Planning Changes Hexham Road, Reading

Reading Borough Council

Ref: HEX-CPM-10-0XX-T-A-00200

This document has been produced by CPMG on behalf of Morgan Sindall to seek a Minor Material Amendment to the following planning application permission:

IMAGES OF THE PROPRIETARY SYSTEM PROPOSED (images by others and indicative only):

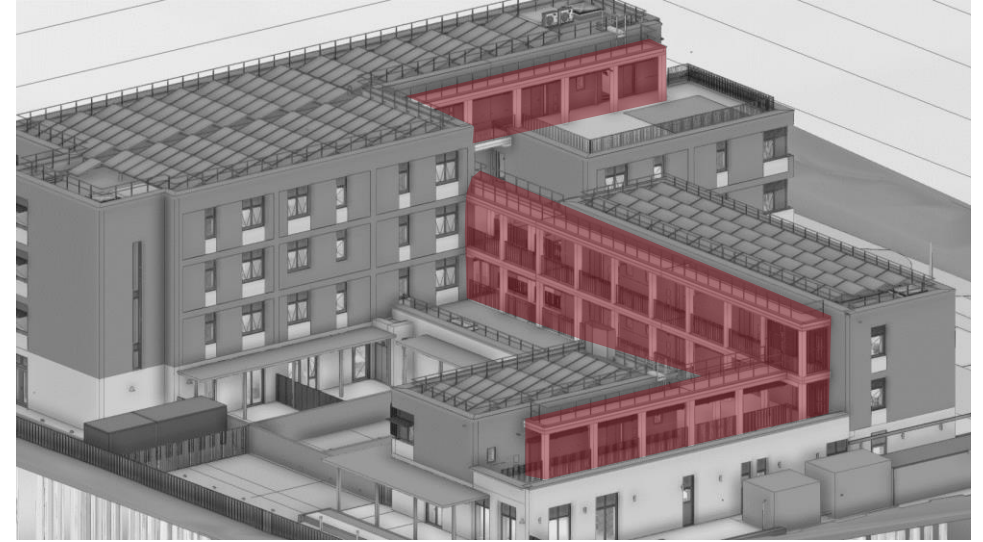
- 1.1 - Canopy omitted to West elevation
- 1.2 - Canopy partially omitted to South and East elevations
- 1.3 - Remaining canopies to North elevation and courtyard changed from brick colonnade to proprietary aluminium with solid roofs

- Lighter and more simple appearance.
- Approved brick colonnade was breaking the thermal line. The self-standing canopy proposed complies with the thermal bridge detailing required for Passivhaus buildings.

3D image as Proposed

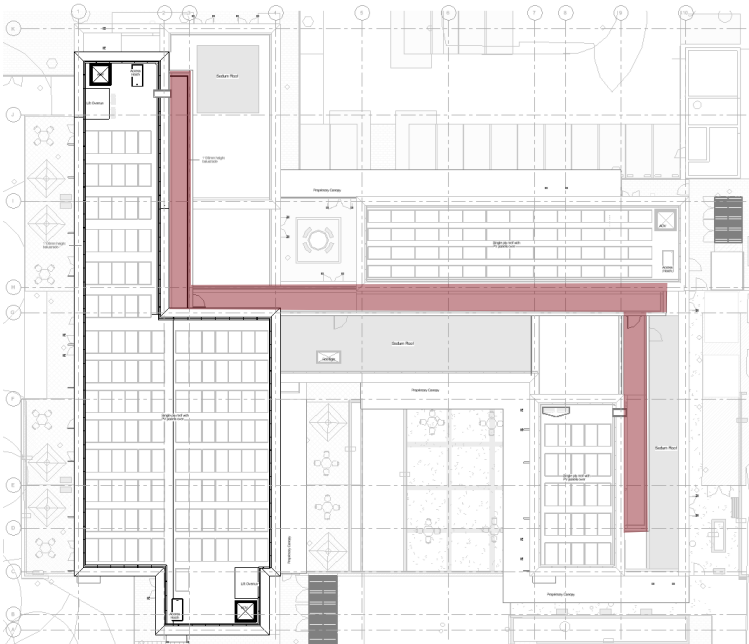
- 2.1 – Walkways (including columns, slabs and edge/fascia) changed from brick to exposed reinforced concrete
- 2.2 – Soffit omitted

- Lighter appearance
- Less susceptible to vandalism
- Client request for maintenance purposes

Extract of the East Elevation as Approved

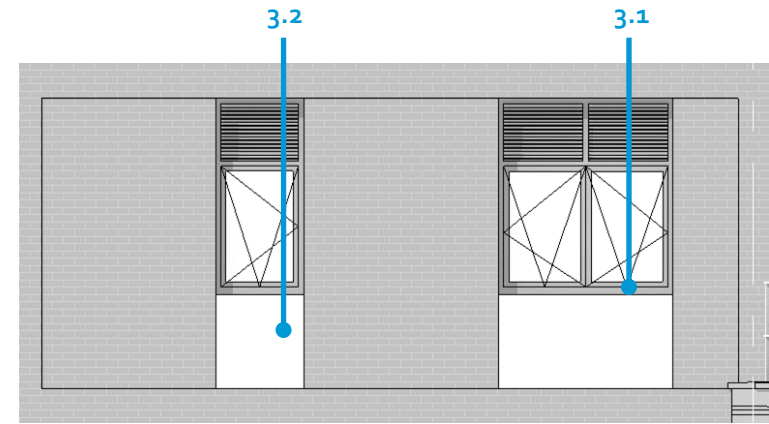
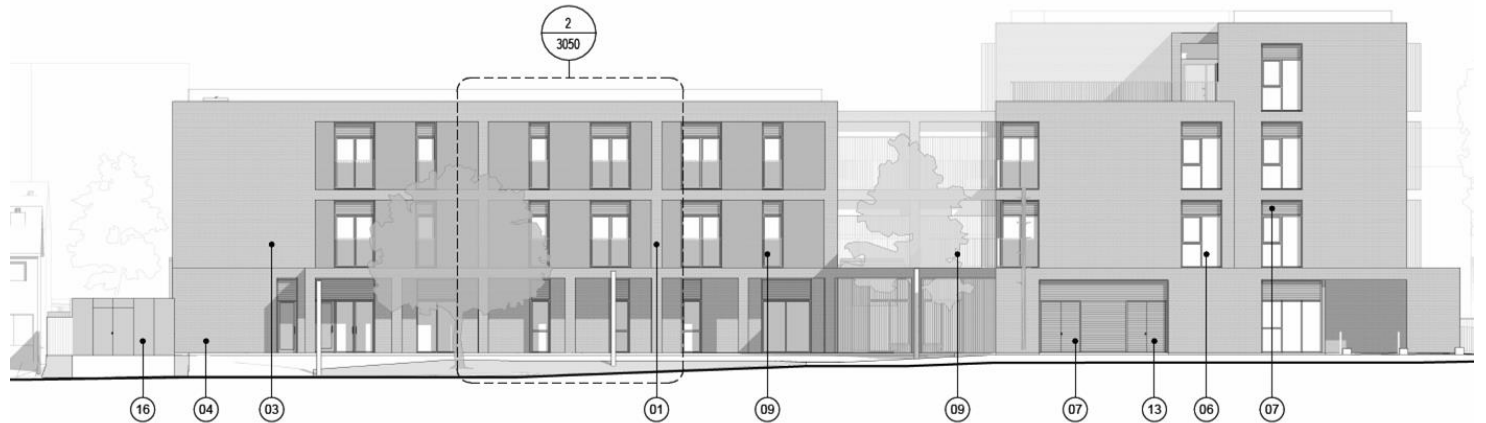
- 3.1 – Cill raised at 1100mm high with contrasting silver grey brick panel below
- 3.2 – Omission of Juliette balcony metalwork
- 3.3 – Omission of metal solar shading to East elevations

- Window reduced to avoid overheating from solar gains in compliance with Building Regulations Part L and O and Passivhaus principles of the scheme. Glazing below 800mm provides little benefit to internal daylight levels albeit larger heat loss in winter and overheating in summer. Additionally, Passivhaus principles suggest horizontal windows are recommended as they are typically easier to shade, hence lowering the risk of overheating.
- Raised cills improve the privacy in habitable rooms.
- Metal solar shading kept where required to avoid overheating in line with the Passivhaus analysis provided by expert consultant (PHPP)

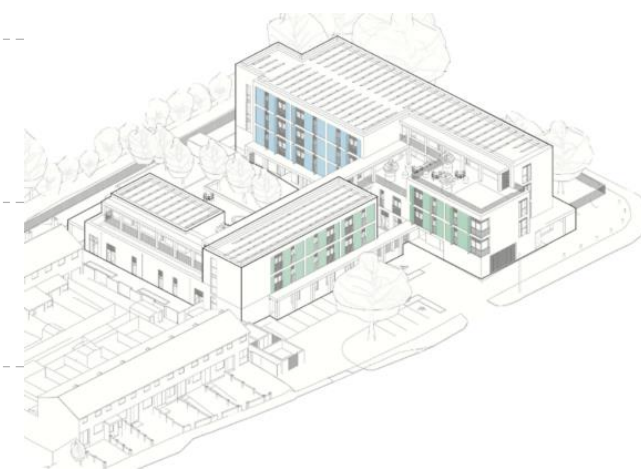
- 4.1 – Flemish bond (highlighted in blue) changed to stretcher bond
- 4.2 – Projecting Flemish bond headers (highlighted in green) changed to stretcher bond.
Note: Michelmersh brick and contrasting colours remain unchanged

-  As approved: Red multi brick in stretcher bond
As proposed: NO CHANGES
-  As approved: Red multi brick in flemish bond
As proposed: Red multi brick in stretcher bond
-  As approved: Red multi brick in flemish bond with protruding headers
As proposed: Red multi brick in stretcher bond

- Less susceptible to climbing
- Reduce anti-social behaviour
- Minimised steps in brickwork will reduce staining and dirt build-up

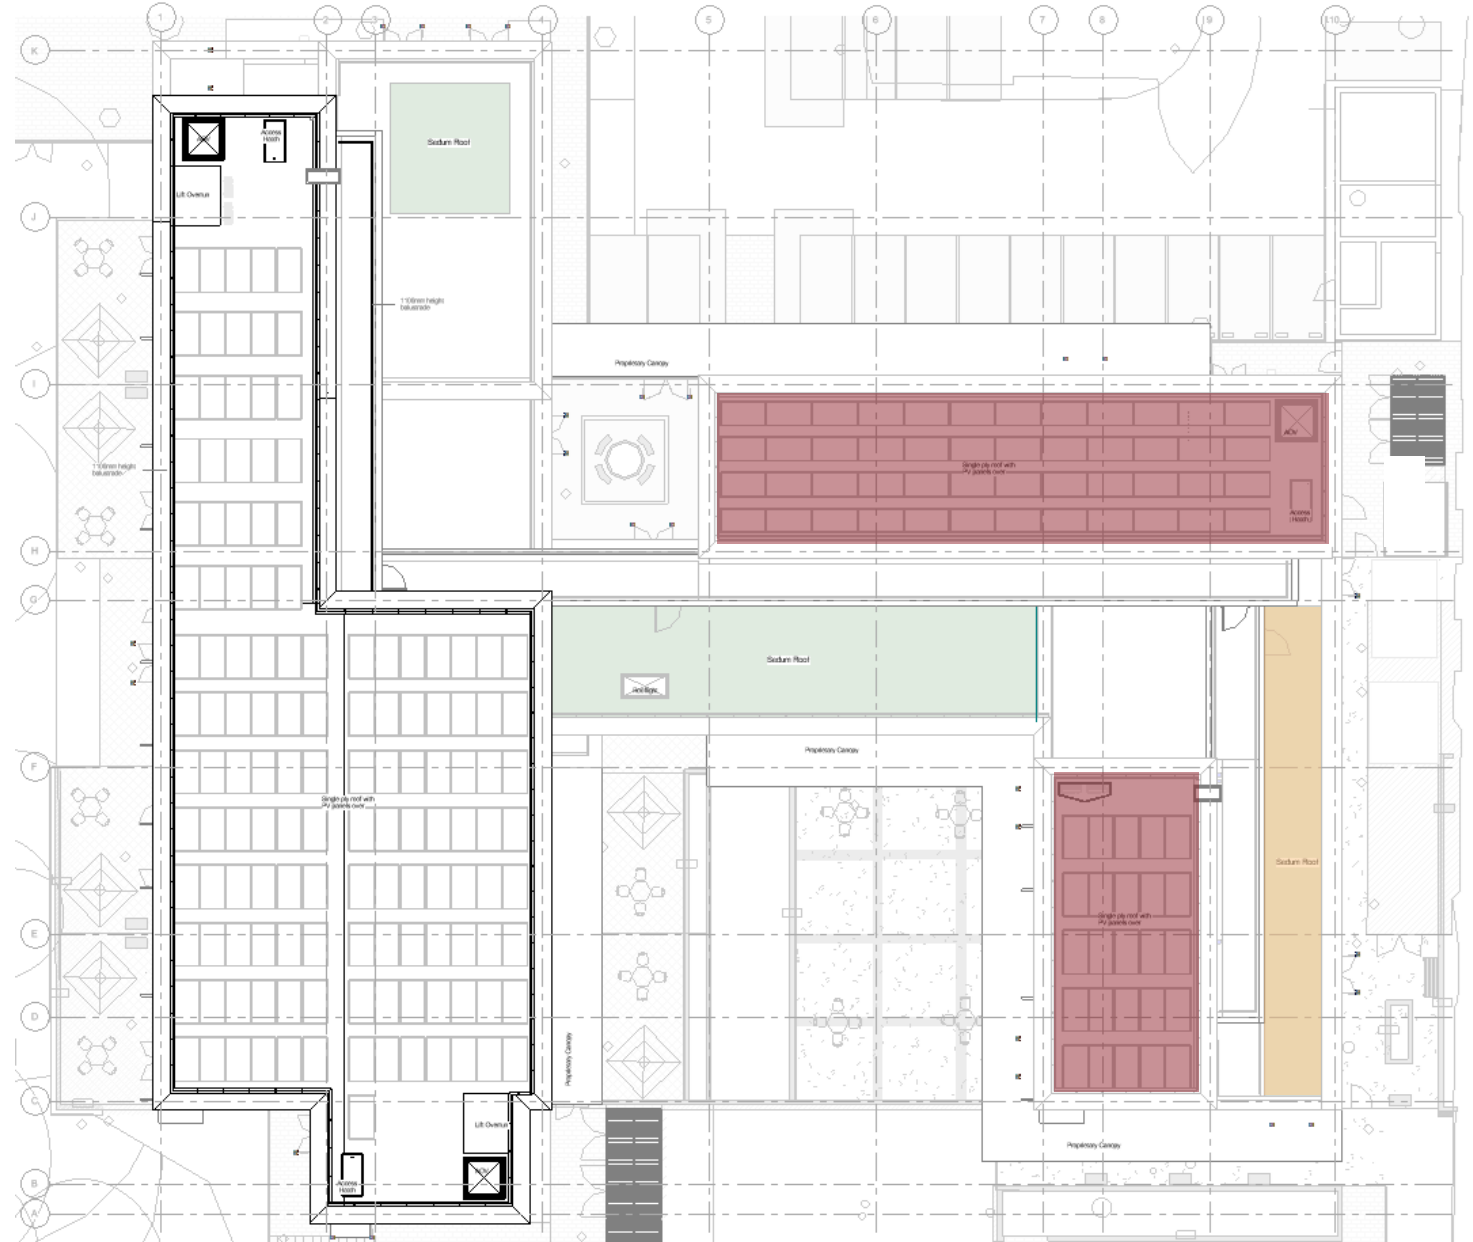
6.1 – Sedum Roof omitted

6.2 – PV panels omitted

-  Retained Sedum Roof
-  Single ply roof with PV panels in lieu of Sedum Roof
-  Omission of PV panels

- Sedum roofs with adjoining building outlook retained whilst sedum roofs with limited outlook and large number of PVs have been omitted.
- The number of PV panels provided at the roof would difficult the growth of the sedum roof and associated maintenance.
- Omission of PV panels to lower roof over PMLD. The panels had limited efficiency due to orientation and overshadowing by adjoining buildings.

External Plant as Approved

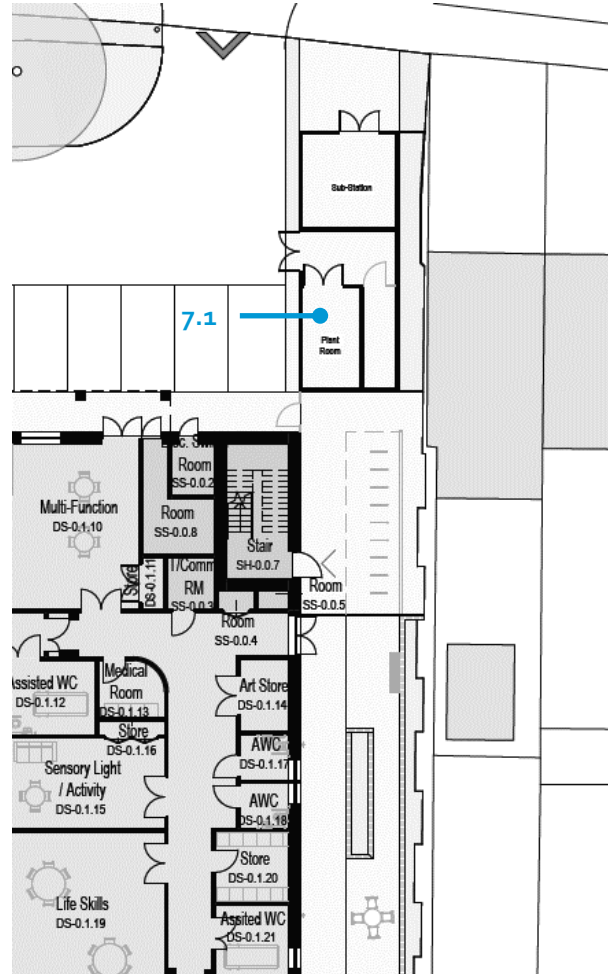
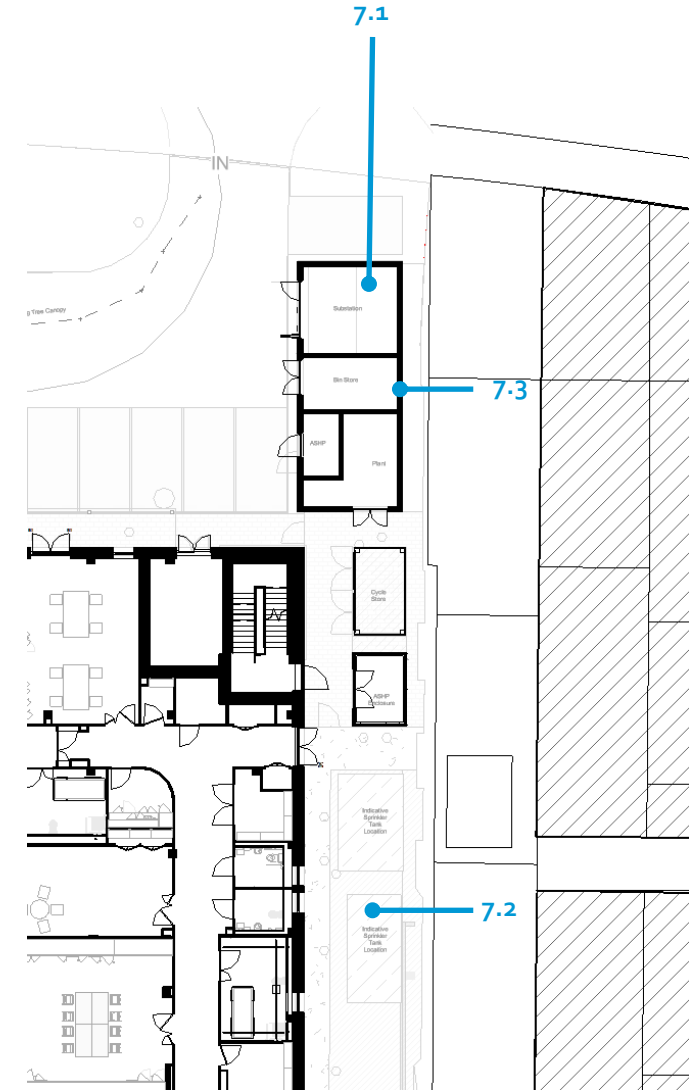
- 7.1 – Layout of external substation/plant/bin changed albeit similar footprint and location
- 7.2 – Additional sprinkler tank (galvanised steel tank) and associated enclosure (Jackson Fencing - Level Top Featherboard Panel 1.8m high with 150mm gravelboard)
- 7.3 – External appearance of substation/plant/bin changed to masonry overlaid in fibre cement panels

- Comply with building requirements in terms of MEP equipment and bin storage
- Building has been upgraded with sprinkler system throughout to enhance the fire safety of the residents.
- Underground sprinkler tanks are not acceptable under British Standards

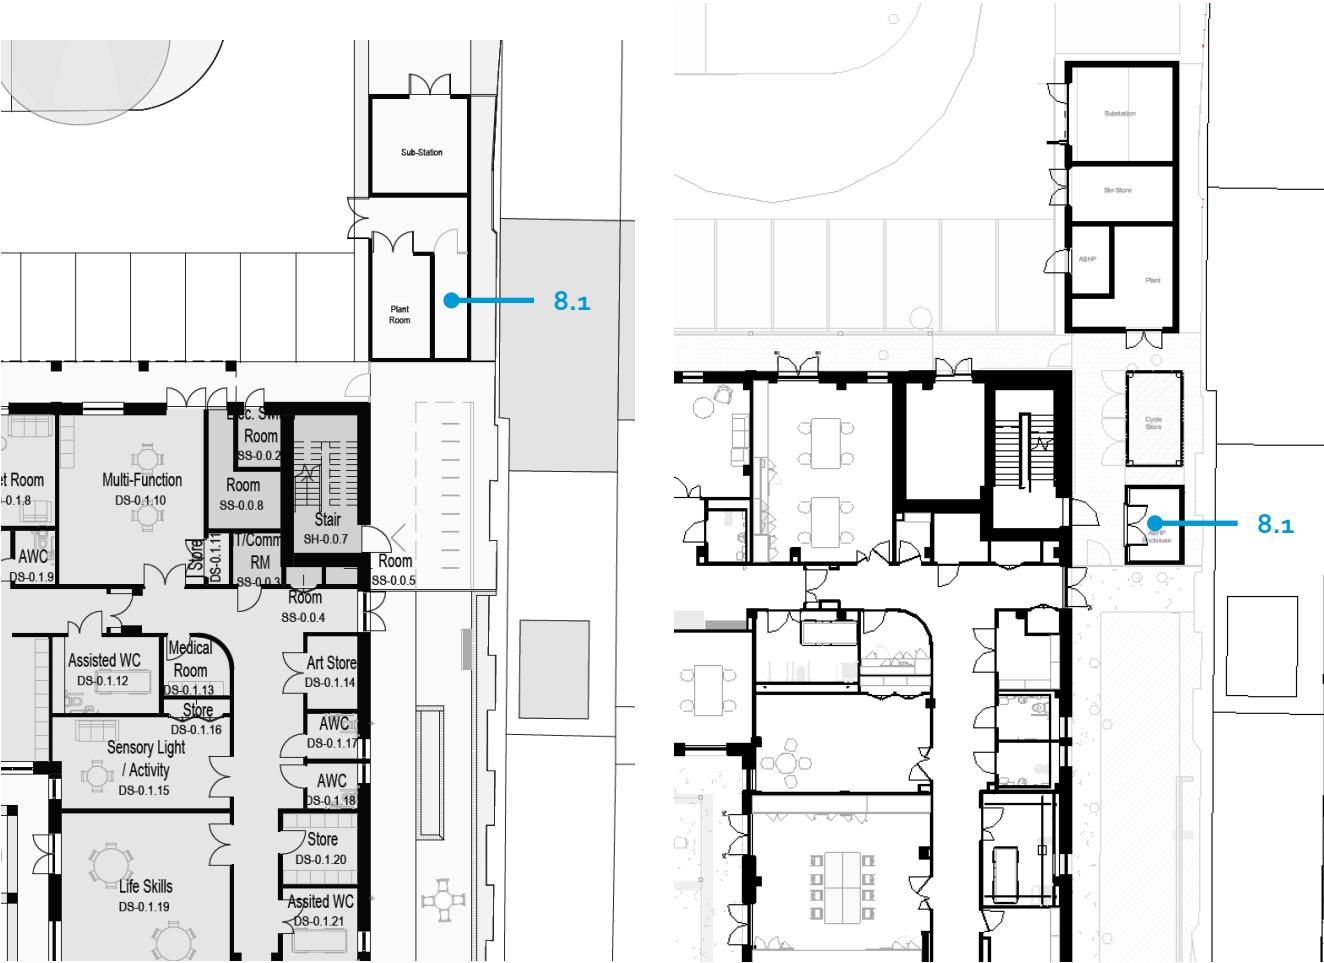
8.1 – Relocation of ASHP units to bespoke enclosure

- To mitigate plant noise levels in the approved location, the required acoustic attenuation would have resulted in insufficient airflow to the plant units.
- The external plant has been relocated to two separate locations, ground floor and second floor roof, as neither have enough space to accommodate all 4 units.

External Plant as Approved

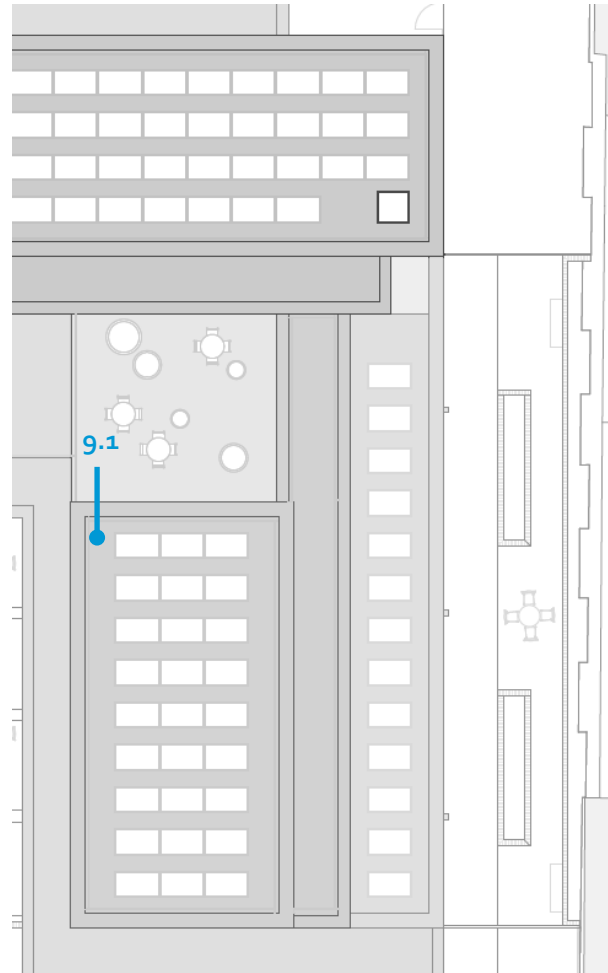
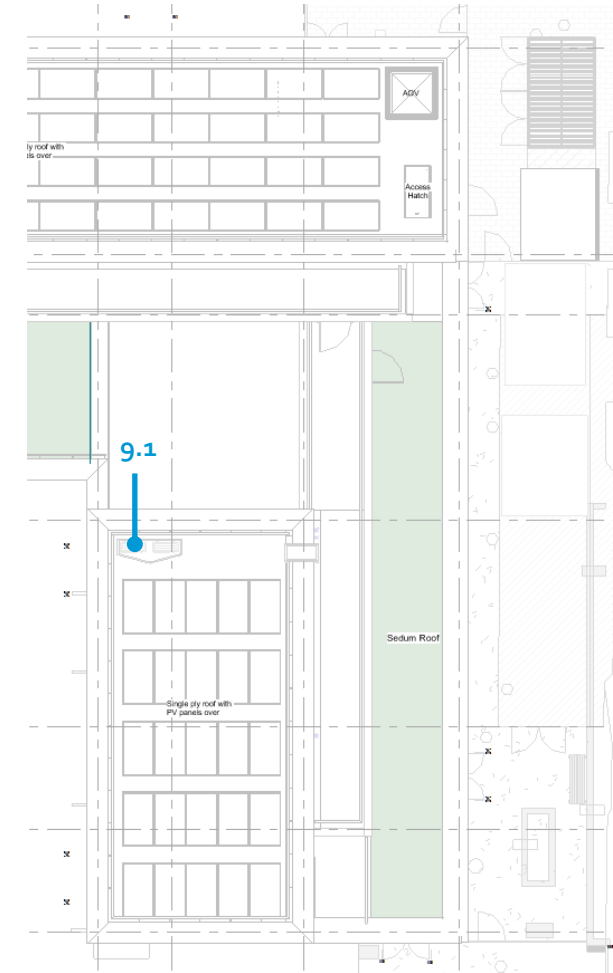
- 9.1 – Relocation of condensers to the second-floor roof. The condensers are surrounded by a solid barrier to the north, east and west, and louvred screen to the south.

- To mitigate plant noise levels in the approved location, the required acoustic attenuation would have resulted in insufficient airflow to the plant units.
- The external plant has been relocated to two separate locations, ground floor and second floor roof, as neither have enough space to accommodate all 4 units.

Site Plan As Approved

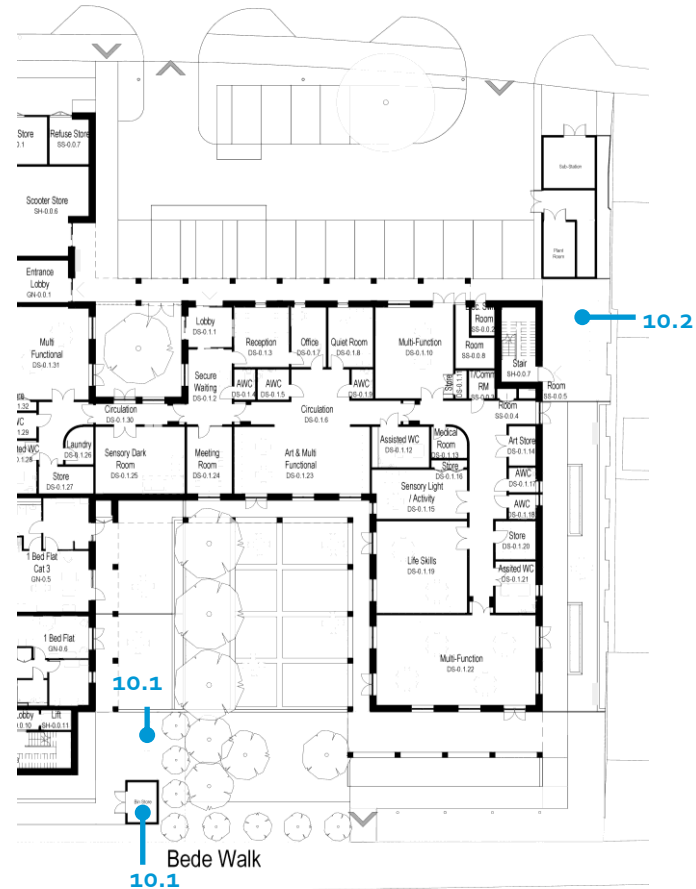
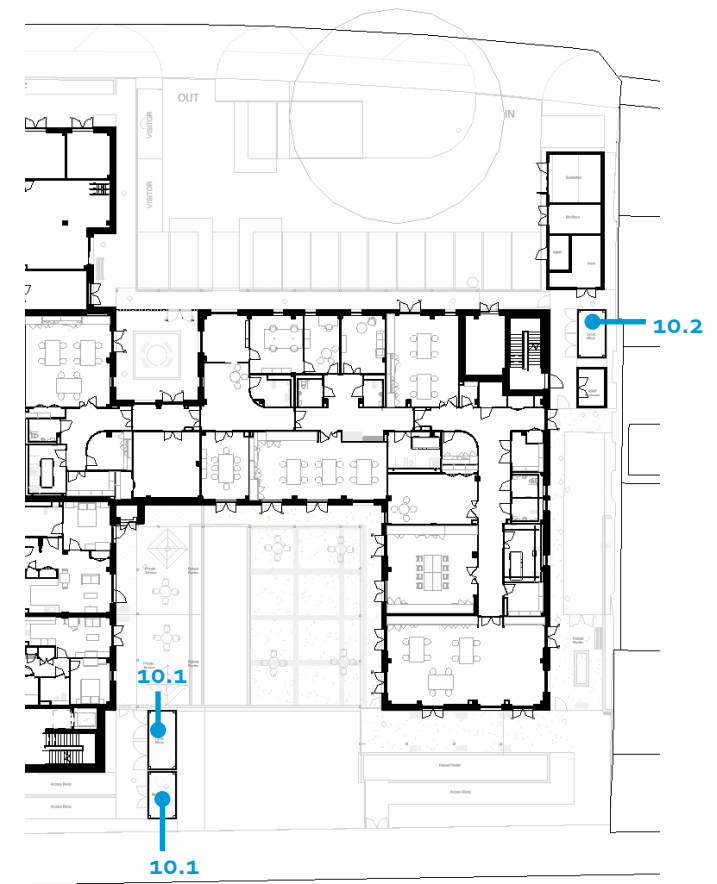
- 10.1** – External appearance of external cycle stores and bin store changed to hit and miss timber clad enclosures
- 10.2** – Northern cycle store changed to accommodate a two-tier cycle rack instead of Sheffield stands, as approved. Southern cycle store remains as approved with Sheffield stands.
- Please note: There is no overall reduction in the provision of cycle spaces. The approved scheme provides 30 spaces, and the proposed scheme provides 32 spaces.*

- Updated to reflect coordination with product manufacturer
